MAINE TURNPIKE AUTHORITY

ADDENDUM NO. 4

CONTRACT 2022.07

INTERCHANGE IMPROVEMENTS

SIGNAL NOTES

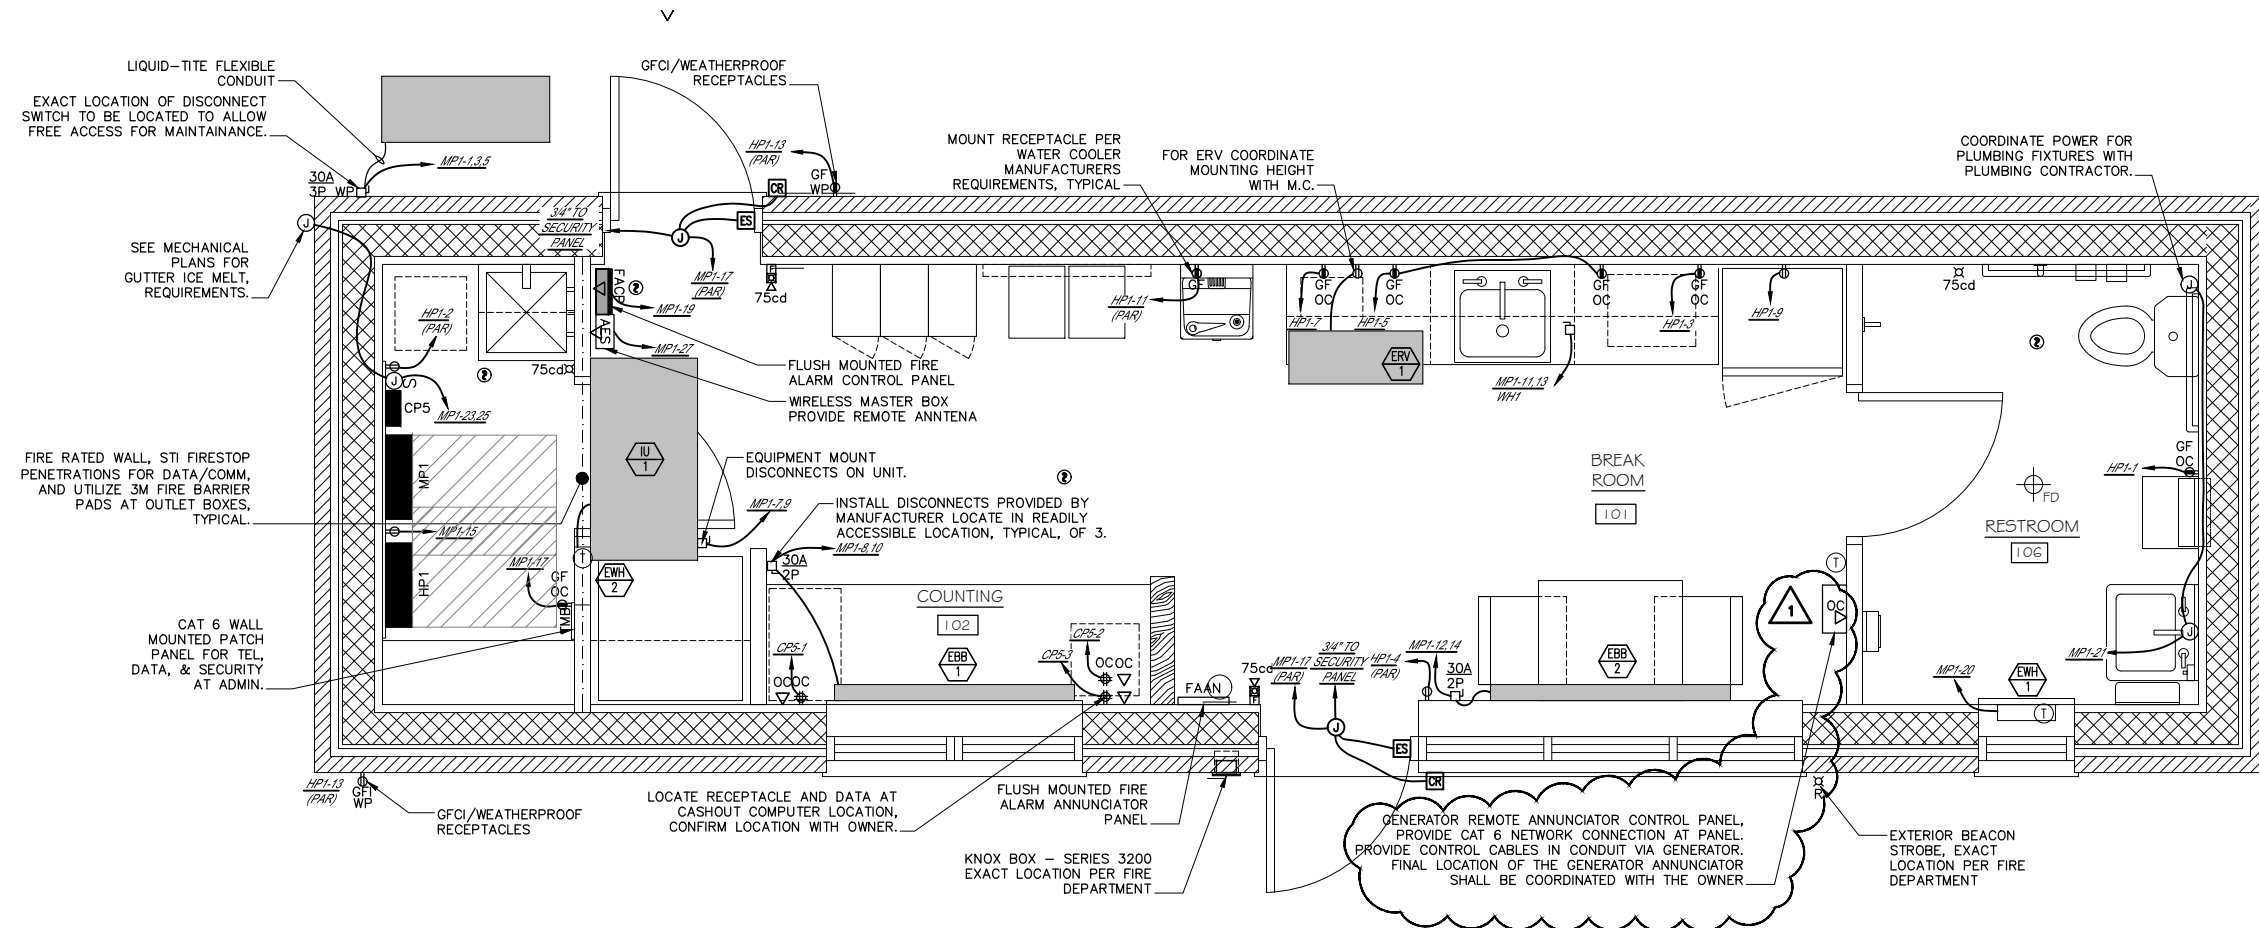
- Plan Sheet 268 of 735, SIGNAL PLAN 2, has been deleted in its entirety and replaced with Plan Sheet 268 of 735, included in this addendum.
- Plan Sheet 269 of 735, SIGNAL NOTES, has been deleted in its entirety and replaced with Plan Sheet 269 of 735, included in this addendum.

26. FOUNDATIONS FOR PEDESTAL POLES SHALL BE 18" DIAMETER FOUNDATIONS AND WILL BE PAID FOR UNDER ITEM 626.31 - 18 INCH DIAMETER FOUNDATION.

No.	Revision	By	Date
1	ADDED NOTE	JRH	11/22
